Groundwater Application Review Summary Form

Application # G- 18599

To: Kristopher Byrd, Well Construction and Compliance Section Manager
From: Joel Jeffery, Well Construction Program Coordinator
Subject: Review of Water Right Application G-18599
Date: August 22, 2018

PUBLIC INTEREST REVIEW FOR GROUNDWATER APPLICATIONS

Figure 1: Water levels in nearby wells measured between April and June to show long-term trends.

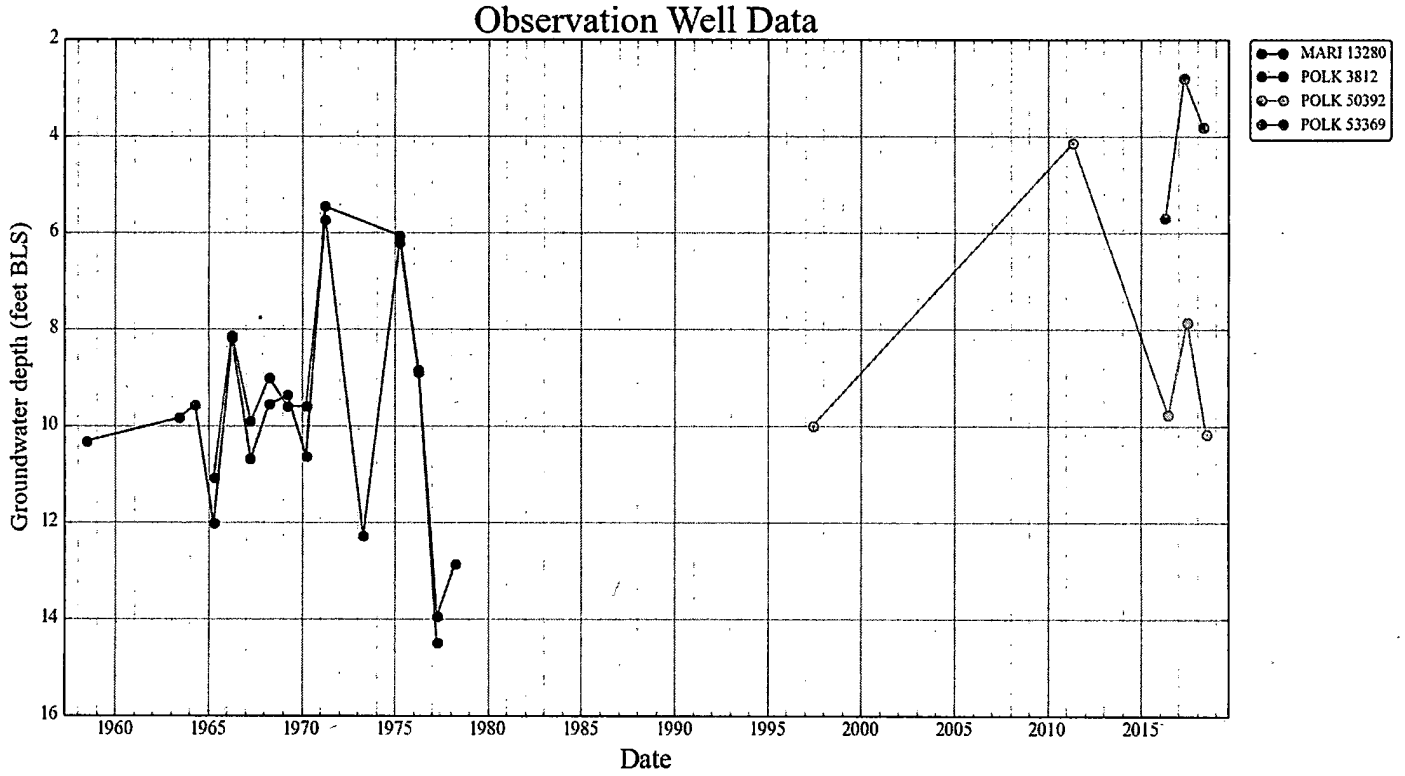
The nearest monitoring wells are POLK 3812, POLK 50392 and POLK 53369, all within 1.5 miles. The correspondence between POLK 3812 and MARI 13280, 3.7 miles to the north and on the other side of the Willamette River, shows how closely water levels in this system are tied to the Willamette River stage. For this reason, the long term stability of the aquifer is not likely to be a problem, but if a permit is granted, the recommended permit conditions should be included to monitor and protect the resource.

Figure 2: Water levels in nearby wells, showing seasonal variability.

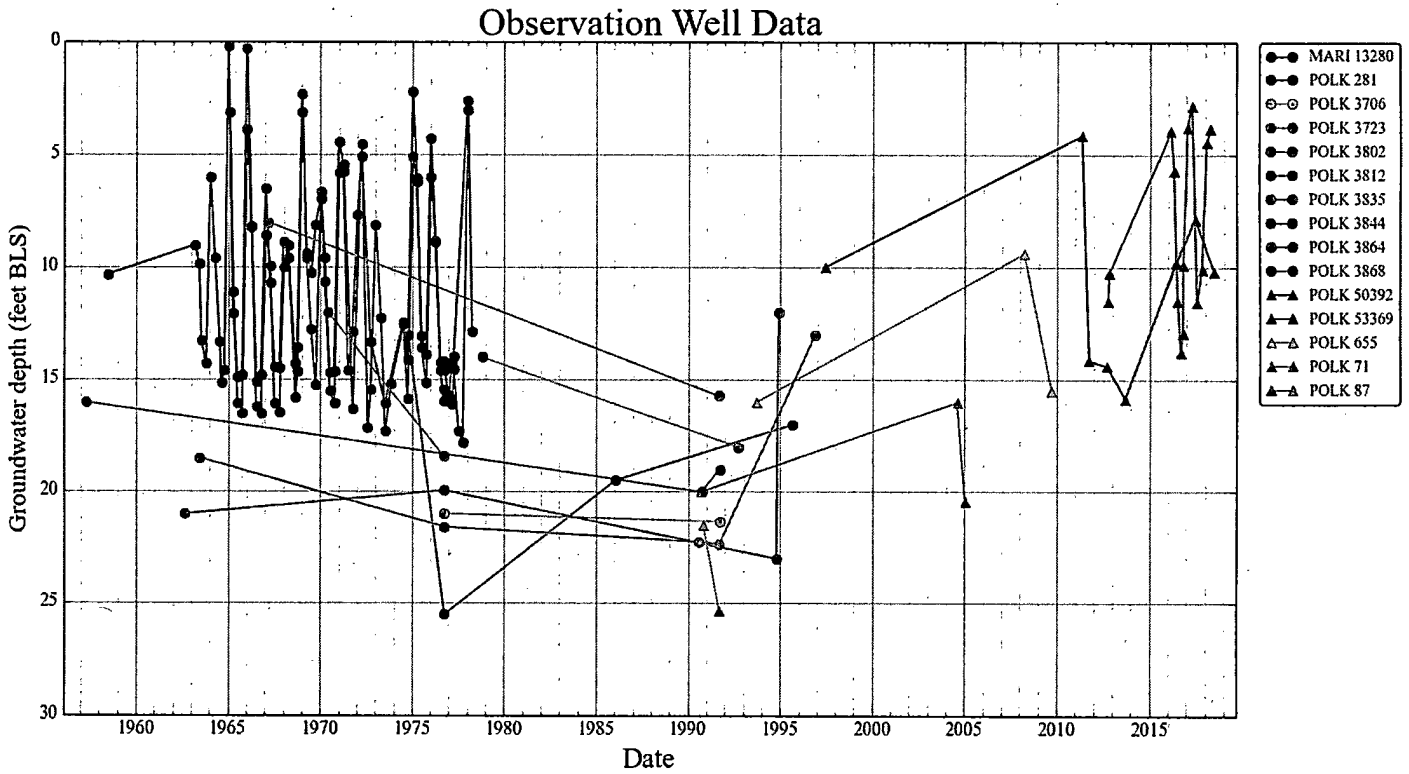
Water levels fluctuate seasonally by approximately 10 feet, according to levels in POLK 53369, and some nearby wells producing from the aquifer system have relatively shallow perforated intervals that make them susceptible to injury (for example, POLK 3888). Therefore, if a permit is granted the recommended permit conditions should be included to protect existing groundwater users.
